Access Compliance Report

Public Rights-of-Way

(Curb Ramps)

Intersection ID: 43093	Main Street: N_POPLAR_ST	Cross Street: W_10TH_ST	Location:	N
ADA ID: 1346390E2F88	Ramp Type: PerpDiag	Initial Pass/Fail: Fail	Overall Compliance: No	Severity Score: 25

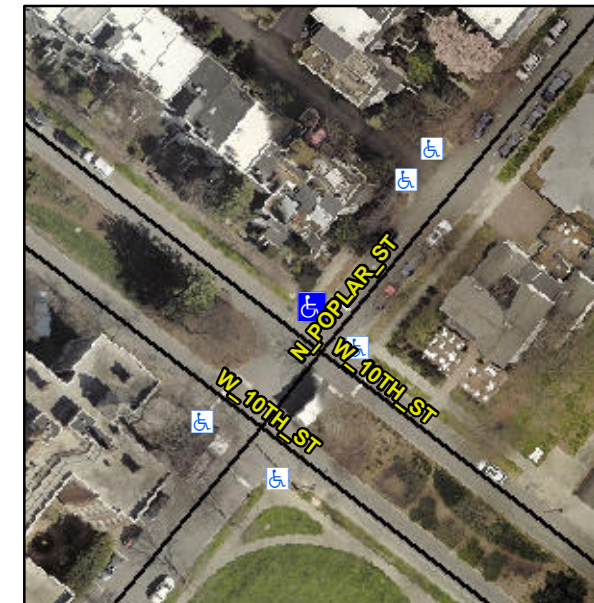
Not Found, R304.5.3

Compliance	Description	Data	Compliance	Description	Data
N/A	Ramp Length (in)	72.0	Yes	Ramp Slope (%)	6.6
Yes	Ramp Width (in)	55.0	No	Ramp XSlope (%)	8.2
N/A	Flare Type LT	N/A	N/A	Flare Type RT	N/A
N/A	Flare Slope LT (%)	N/A	N/A	Flare Slope RT (%)	N/A
N/A	Flare Traversable LT?	N/A	N/A	Flare Traversable RT?	N/A
N/A	Landing Length (in)	N/A	N/A	DWS Provided?	N/A
N/A	Landing Width (in)	N/A	N/A	DWS Contrast?	N/A
N/A	Landing Slope (%)	N/A	N/A	DWS Length (in)	N/A
N/A	Landing X Slope (%)	N/A	N/A	DWS Full Width?	N/A
N/A	Landing Curb? (Y/N)	N/A	N/A	DWS Offset (in)	N/A
N/A	Shared Landing?	N/A			
N/A	Gutter Ponding?	N/A	N/A	Gutter Slope (%)	N/A
N/A	Gutter Lip Ht (in)	N/A	N/A	Gutter X Slope (%)	N/A
N/A	Painted X Walk1?	No	N/A	Painted X Walk2?	No
	X Walk 1 Direction	To SW		X Walk 2 Direction	To SE
N/A	X Walk 1 Width (in)	N/A	N/A	X Walk 2 Width (in)	N/A
	X Walk 1 Slope (%)	9.7		X Walk 2 Slope (%)	6.8
	X Walk 1 X Slope (%)	3.5		X Walk 2 X Slope (%)	5.8

Remove & Replace Curb Ramp With Two New Directional Ramps or Equivalent.
